**Staff Report
SD-2019-01**

**PRELIMINARY PLAT
 SUBDIVISION MAP
 FOR
 BRICKSTONE SUBDIVISION**

Brickstone Subdivision

**SECTION AA
 TYPICAL CUL-DE-SAC
 NO CURB & GUTTER**

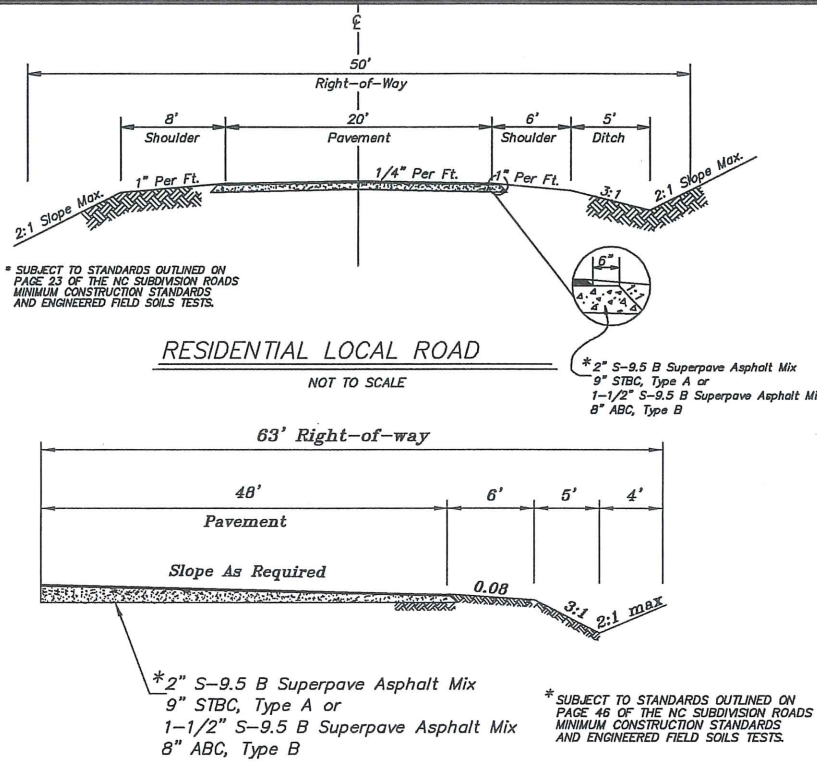
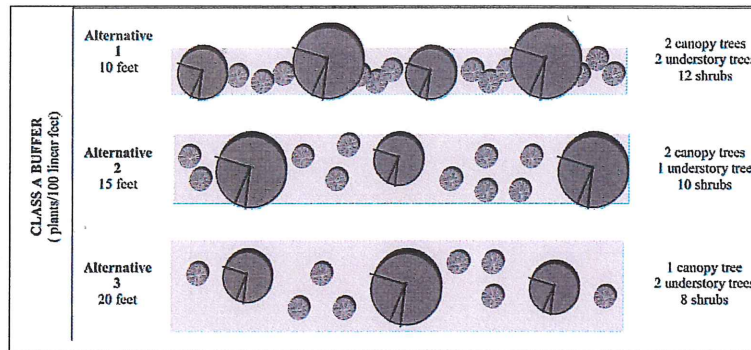
1. Ensure that the cul d sac's measure at least 96 ft. in diameter to ensure Fire Apparatus turn around.
2. Move the hydrant that is across from the entrance of Morgan Ct. west of one or two lots. I see there is a drainage easement between #7 and #8, so it may be better placed between #6 and #7 lots. Either will work fine for operations of the Fire Department.
3. Move the hydrant that is across from the entrance of Taylor Ct. southwest on the other side of Taylor Ct. for operations of the Fire Department.
4. Required: Hydrant in working order and road surface be able to support fire apparatus weight before any combustible materials introduced to the site.
